RE: Blythe Energy Project Transmission Line (99-AFC-8C)
Metropolitan Water District Letters Regarding Insignificant Project Change Request #3

**Request for Approval of Third
Insignificant Project Change
(99-AFC-8C)**

**Blythe Energy Project
Transmission Line**

**Minor Structural Changes, Additional Communications
Systems, and Expanded Work Areas**

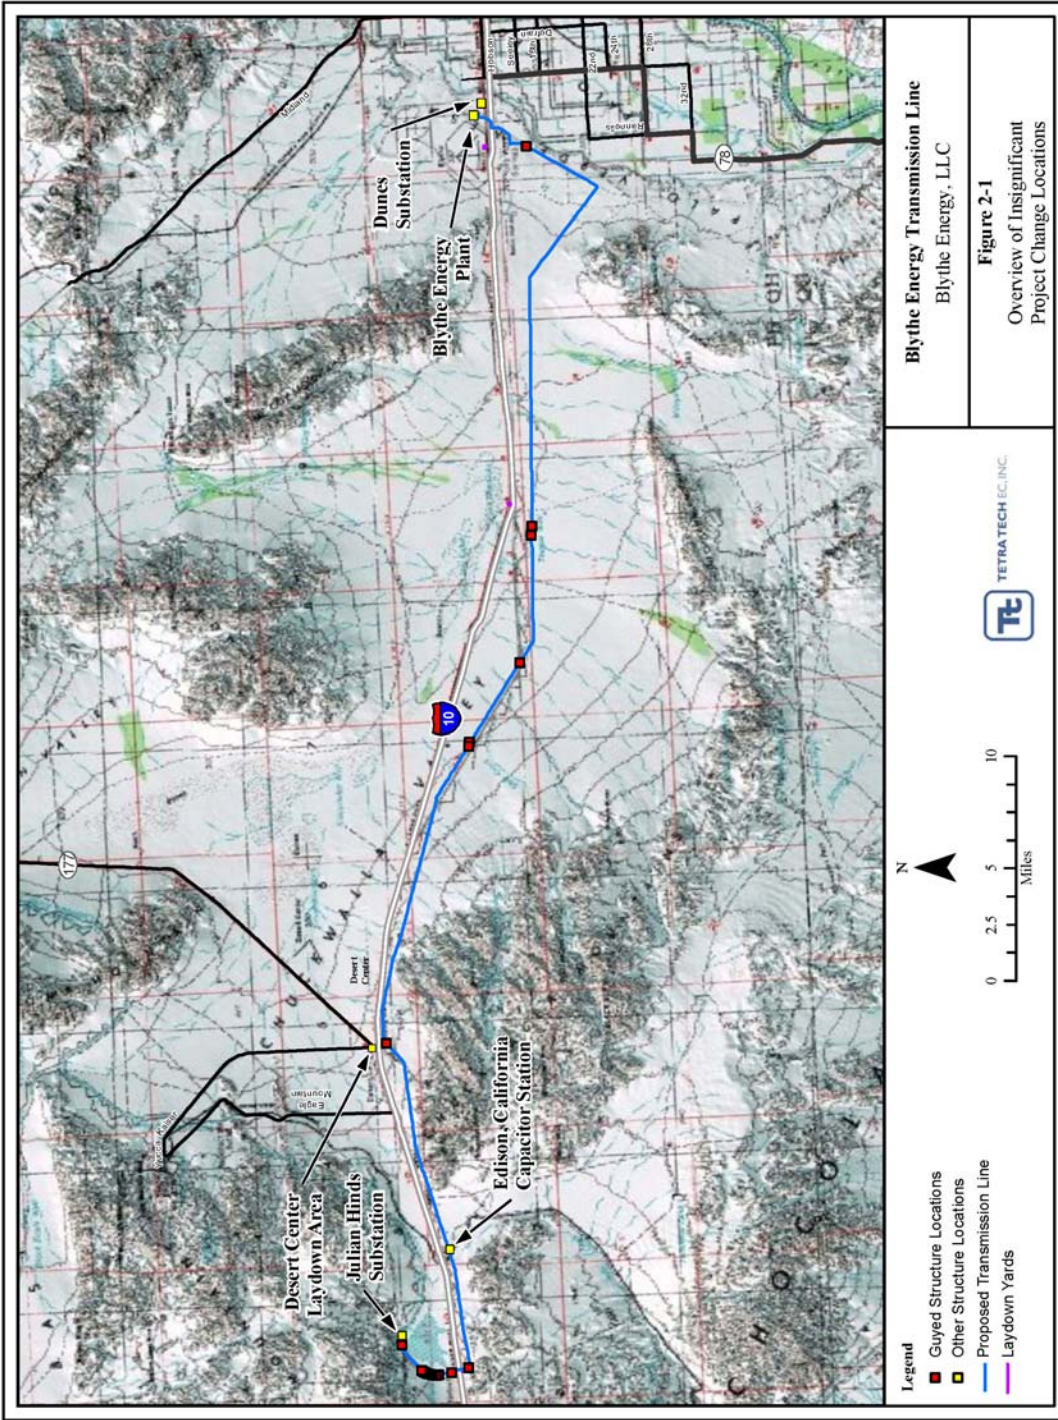
Figure 2-1 illustrates the overall route and the location of the site-specific changes in structure or laydown area location. Table 2-1 summarizes the change in disturbance footprint by proposed insignificant change component. Table 2-2 details the change in underlying land ownership for the various project components between present conditions and proposed changes.

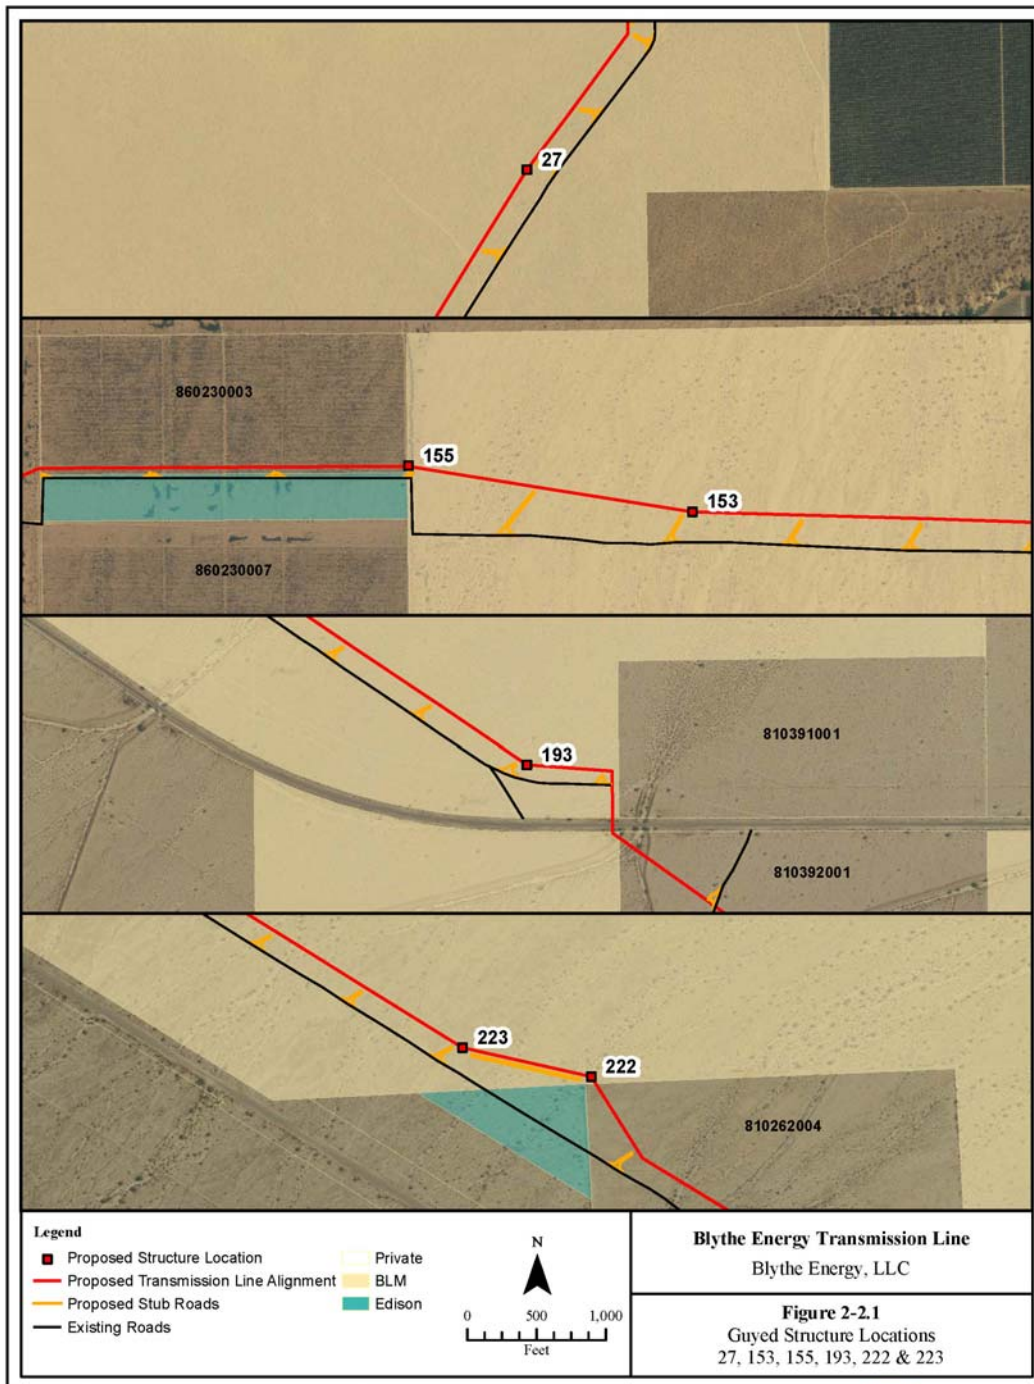
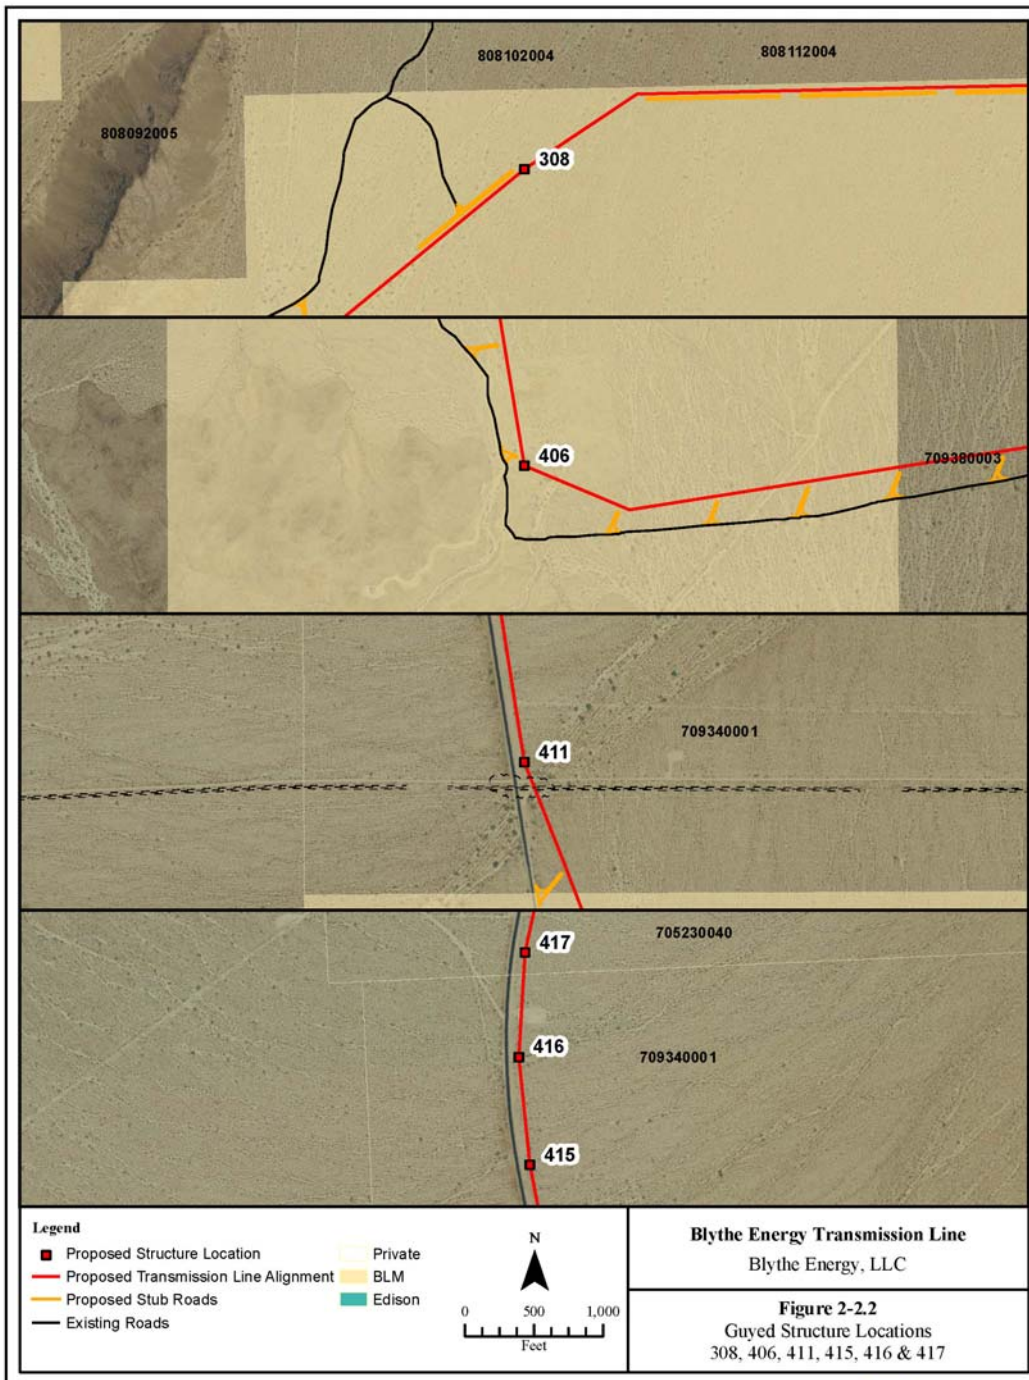
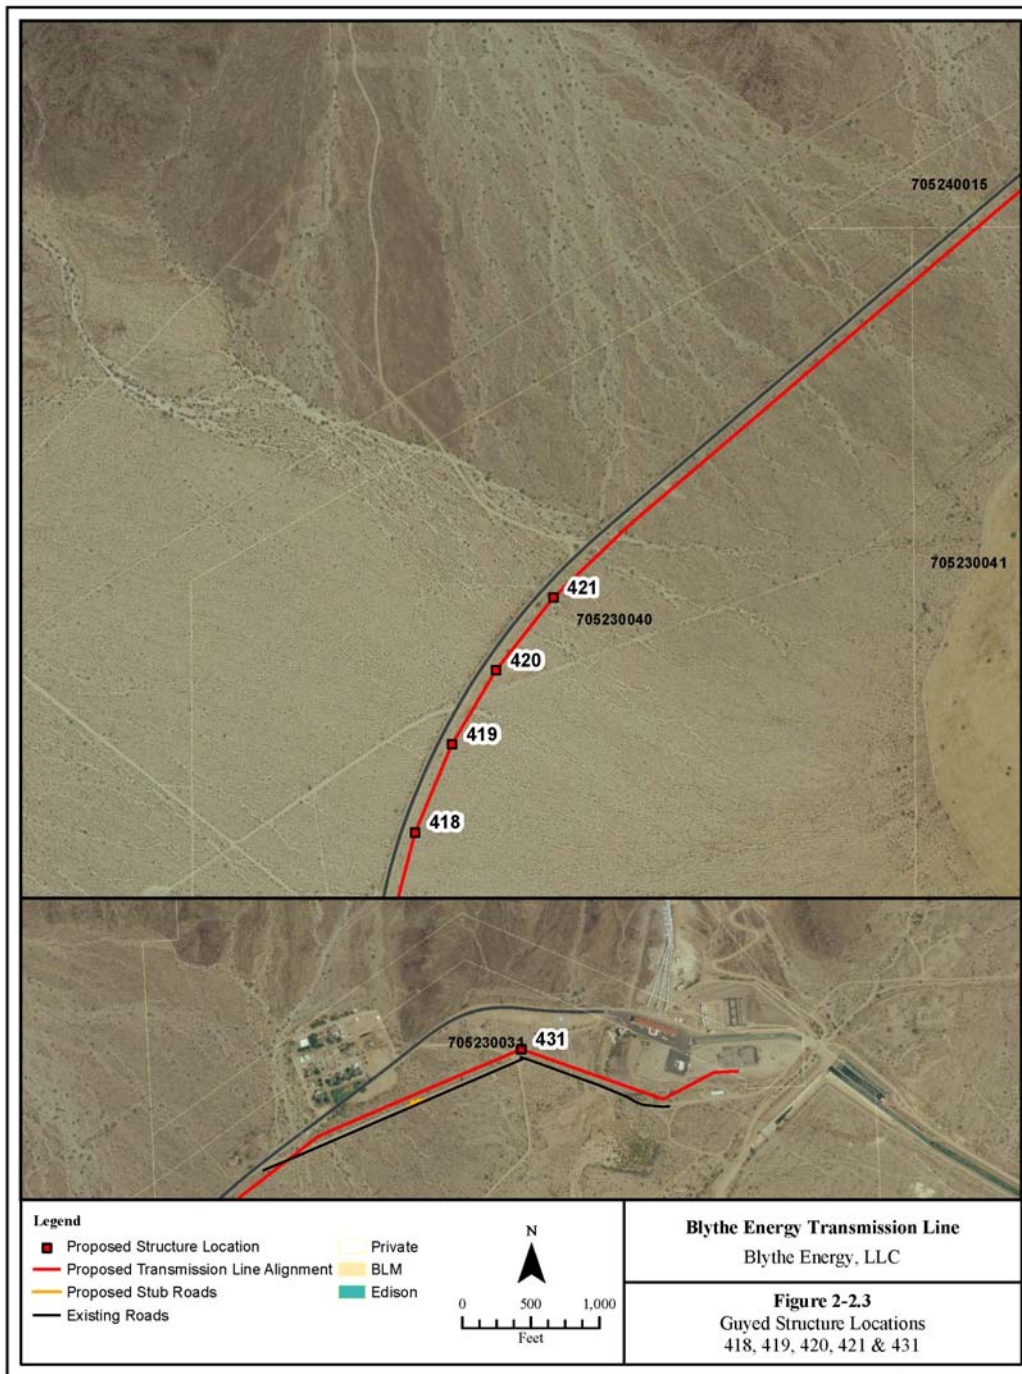
Figure 2-2 is a map of the location of 17 structures that final engineering has determined will require guys to stabilize the structures and to provide for the safety of the public and the reliability of the transmission line. The guy wires, with a diameter of 9/16 inches, extra-high-strength steel, will extend out of the requested 95-foot-wide right-of-way (ROW) by up to 40 feet and averaging around 23 feet. Appendix B contains detailed plan and profile drawings of each of the proposed guyed structures and shows the relationship of the guy wires to the ROW. Note that in no case do the requested guy wires extend beyond the original parcel in which the ROW is located.

The guys are installed by first installing a guy anchor. These anchors are multi-helix shafts that are 10 feet and 7 feet in length. Appendix B also contains specifications from the anchor manufacturing company. The anchors are screwed into the ground with a truck-mounted power auger. They typically reach depths below grade of 8.3 feet and 5.8 feet, respectively. When installed, the anchors will extend horizontally below grade 5.5 feet and 3.9 feet, respectively. If the prescribed torque values cannot be met, then a 20-inch-diameter hole is drilled to match the depth and angle of the anchor. The hole is filled with concrete, and the anchors are screwed into the concrete before it sets.

The extra workspace required to install the anchor will include a one-time track for the drill rig to back up to the guy anchor location and install the anchor, with an assumed width of 12 feet. No new roads or additional clearing will be required, as the trucks can drive over the vegetation if needed. Table B-1 summarizes the requested structures, provides details regarding structure height and angles, and specifies the landowner for each. Table B-2 details the disturbance calculations and their assumptions and includes a summary of the number of guys and guy “runs” along with assumed width and length of disturbance outside the ROW. Appendix B also includes detail plan and profile drawings for each of the guyed structures. The 17 structures and 132 total guy wire “runs” will require a total of less than 0.24 acre of additional disturbance.

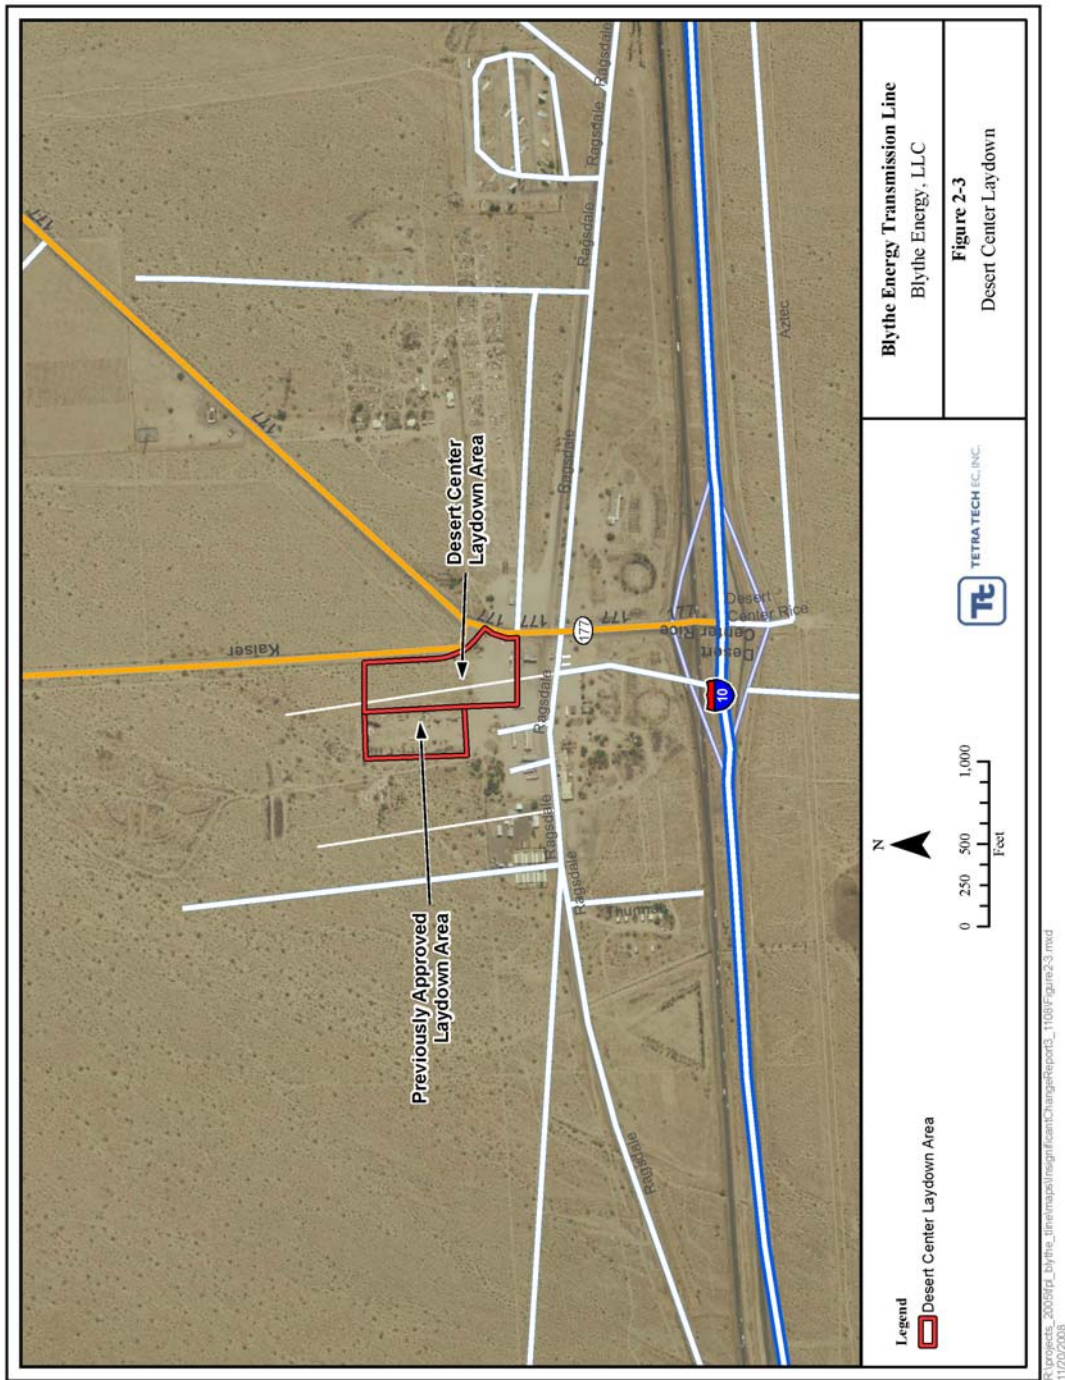
Figure 2-3 illustrates the proposed Desert Center laydown area expansion. The landowners (the Ragsdale family) have given permission for the expansion. The laydown yard will be expanded to approximately 10 acres and will be fenced with both chain link fence and desert tortoise fencing. A biologist will be on-site during fence installation to conduct a pre-construction sweep of the area and to ensure that no tortoises are trapped inside the fence. The area will be cleaned up as specified by the landowner after construction is complete.

Valmont, the manufacturer of the concrete poles, with a factory located in Barstow, has now indicated that its trucks are unable to travel the unsurfaced roads in the desert and separate, high-clearance tractors will be needed to transport the poles. Therefore, additional area is needed at Desert Center to transfer the poles from highway vehicles to the high-clearance tractors.

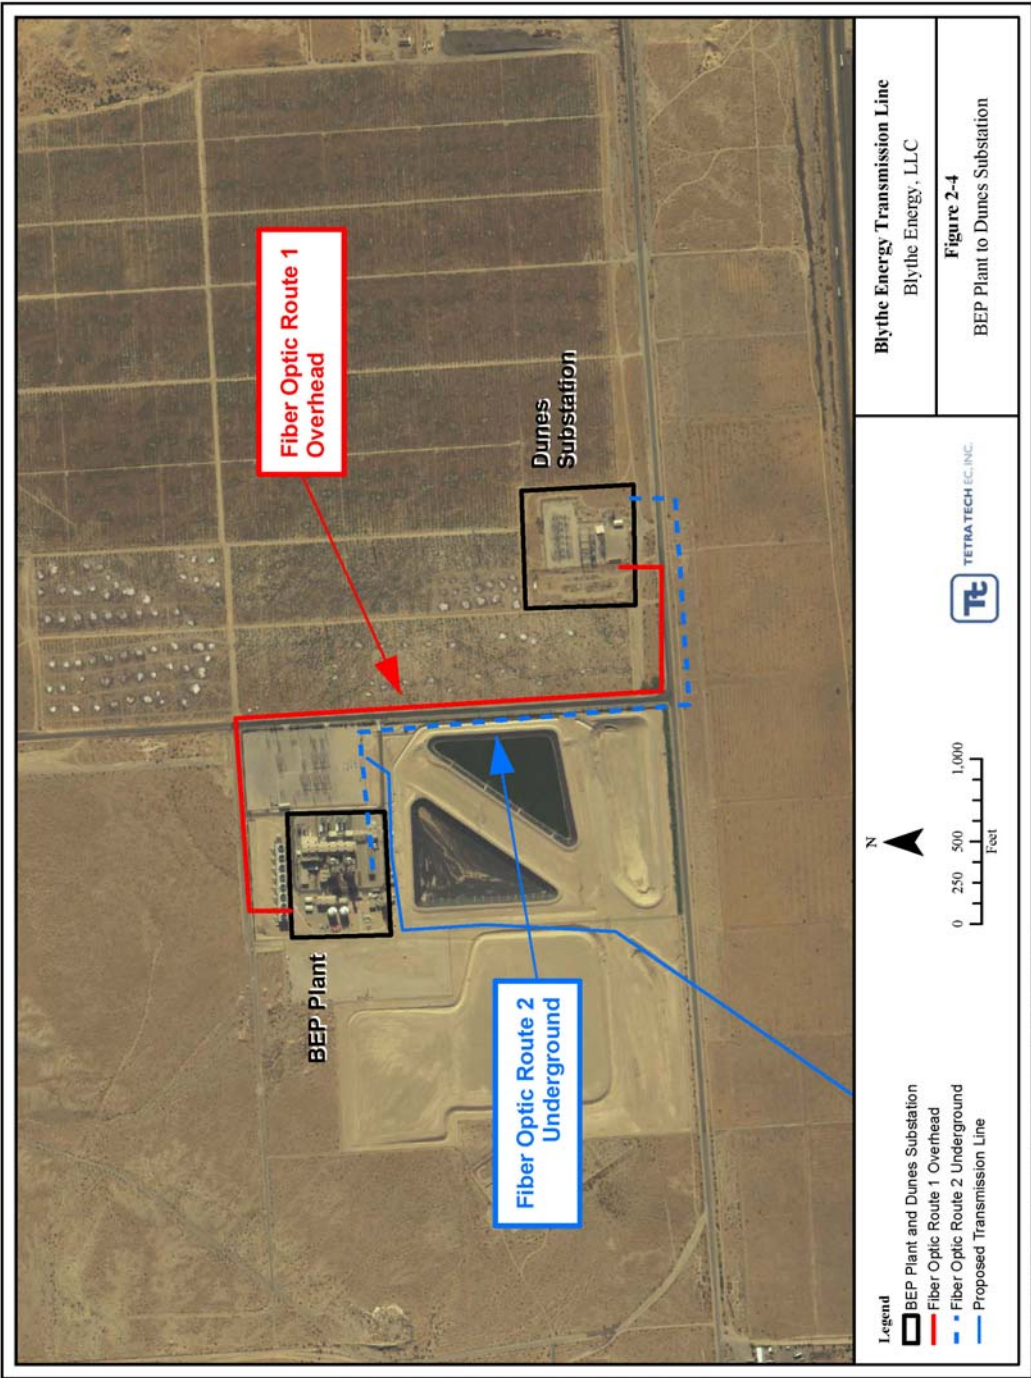
Figure 2-4 illustrates the proposed fiber optic cable routes from the BEP to the Dunes Substation. In addition to the dual fiber optic cable installation, Edison Network Services Engineering (Edison) will require space within a building that will be constructed as part of the improvements within the BEP to accommodate the changed routing of the power. The westernmost cable (FO-2) will travel in an underground conduit installed adjacent to the existing BEP paved entryway, then turn south at the edge of the Buck Boulevard ROW to the Hobson Way ROW. This cable in conduit will be installed with a directional drill underneath Hobson Way, will emerge within the Hobson Way ROW on the south side of the road, and will then turn east and proceed along Hobson Way within and at the edge of the road ROW. It will turn north again under Hobson Way through the use of a directional drill and emerge immediately adjacent to the southeastern corner of the Edison Dunes Substation.

SCE Telecom will construct the easternmost cable (FO-1), overhead for about 5,300 feet on new and existing poles, and for approximately 900 feet in underground conduit. The cable will leave Dunes Substation overhead heading due south to Hobson Way. It will continue west along Hobson Way, along the north side of the road, to Buck Boulevard. It will head north along the east side of Buck Boulevard. At Riverside Avenue it will turn west and cross Buck Boulevard and run along the south side of Riverside Avenue to the west side of the Blythe Energy Plant. It will then come down on a riser pole to continue underground to the south, into the Blythe Energy Plant.

Edison stated that the BEP-Dunes Fiber Optic Path is needed to provide a link to the existing SCE Telecommunications network to meet SCE's protective relaying requirements. Edison has therefore concluded that a new optical information system station is required at the BEP to provide needed communications and control, and that a fiber optic path is needed to existing communication equipment found in Edison's Dunes Substation. The fiber optic path needs a redundant component to provide for the unlikely event that one of the fiber optic paths is interrupted and to guarantee communication between the BEP and the Edison portion of the Southern California grid.
